DART AEROSPACE LTD		Work Order:	71375
Description: Crosstube High Aft (412)		Part Number:	D412-664-203
Inspection Dwg: D412-664-243 Rev: E		Page 1 of 1

DRAWING NO. D412-664-243	TITLE CROSSTUBE ASSEMBLY (412 HI AFT)	REV. E	DART AEROSPACE LTD ENGINEERING ORDER		D.E.O. NO. D412-664-243-E-1	SHEET NO. SHEET 1 OF 2	SCALE NTS
DRAWN	CHECKED	MFG. APPR.	APPROVED	DE APPR.			
DATE 11.03.31	DATE 11/03/31	DATE 11.03.31	DATE 11/03/31	DATE 11.03.31

DRAWING NO. D412-664-243	TITLE CROSSTUBE ASS'Y (412 HI AFT)	REV. E	DART AEROSPACE LTD ENGINEERING ORDER		D.E.O. NO. D412-664-243-E-2	SHEET NO. SHEET 1 OF 1	SCALE NTS
DRAWN 97	CHECKED SS	MFG. APPR. E	APPROVED MP		DE APPR. H		
DATE 11.09.07	DATE 11.09.19	DATE 11.09.19	DATE 11.09.19		DATE 11.09.19

**D412-664-243
ASSEMBLY DETAIL**

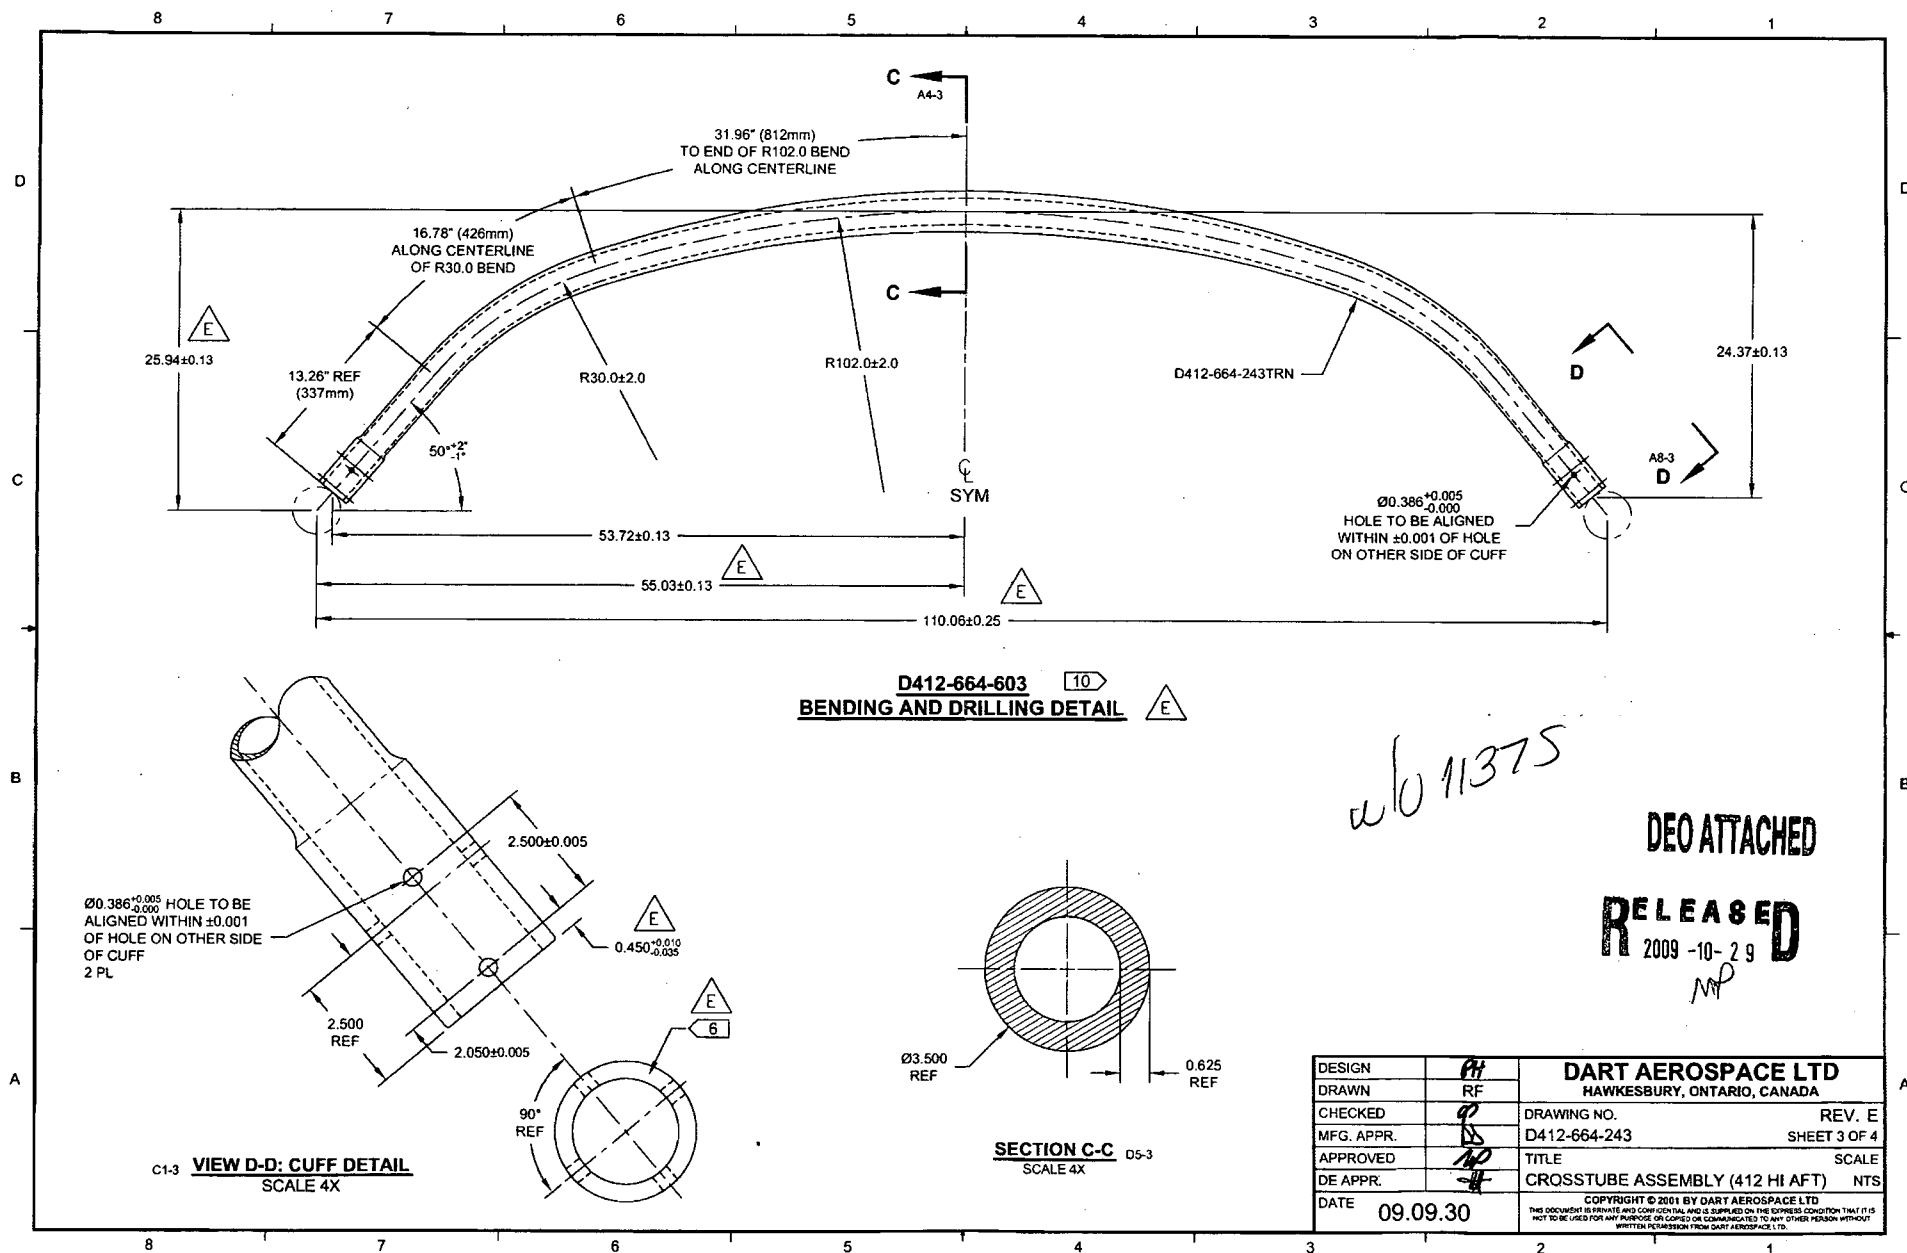
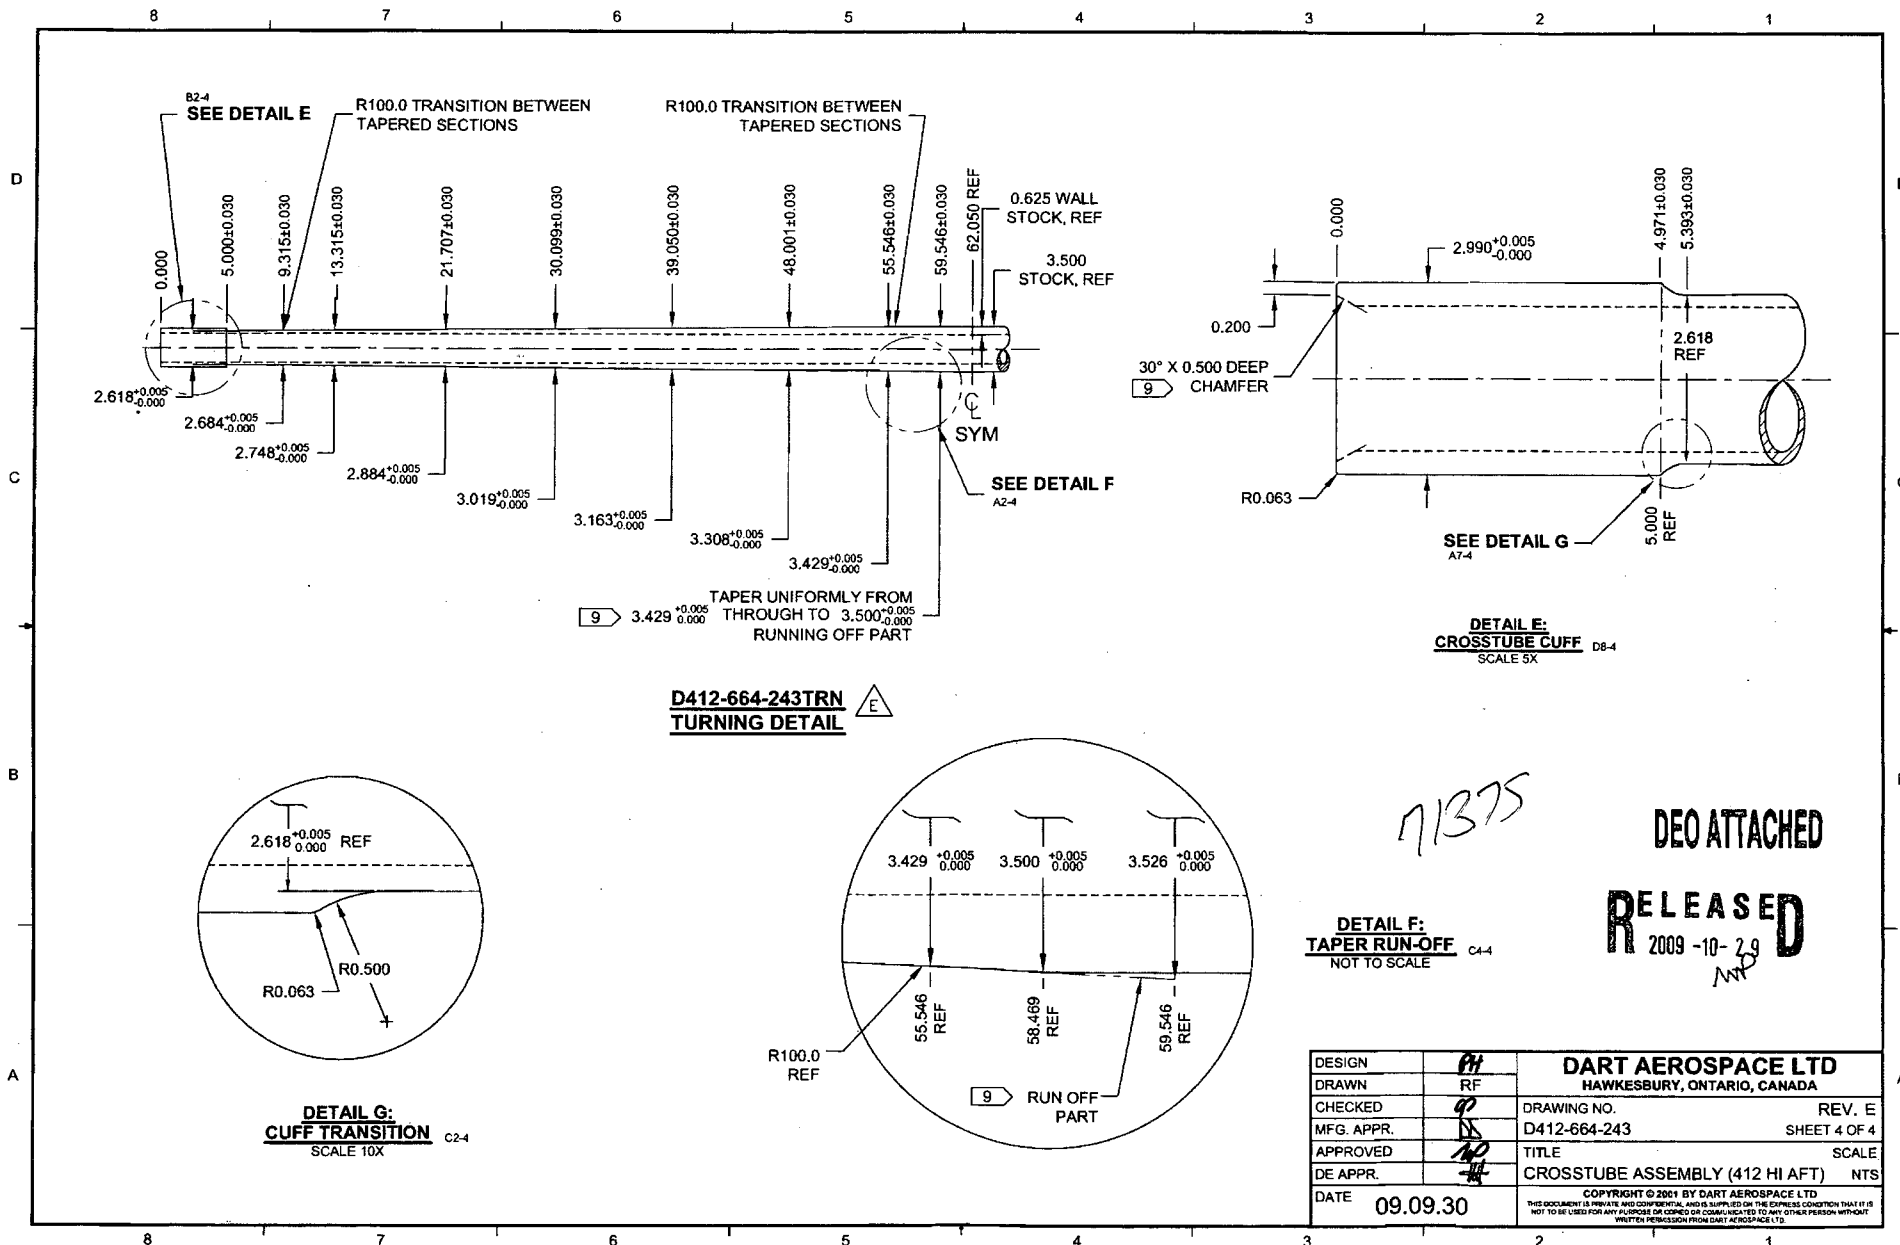
PURPOSE:

REMOVED ABRASION STRIP IN FAVOR OF A THIN LAYER OF PROSEAL 890.

NOTES 2 AND 14, SHEET 1 ARE AMENDED AS FOLLOWS:

IS:

D2856-600-1009 ABRASION STRIP
D3189-1 CHAFING SHIELD (1, INSTALLED OVER ABRASION STRIP)
MS21920-28 CLAMP, 2X
2 PL

D3189-1 CHAFING SHIELD (1, INSTALLED OVER PROSEAL 890)
MS21920-28 CLAMP, 2X
2 PL

MASK AREA PRIOR TO PAINTING AND
APPLY CLEAR COAT AFTER PAINTING
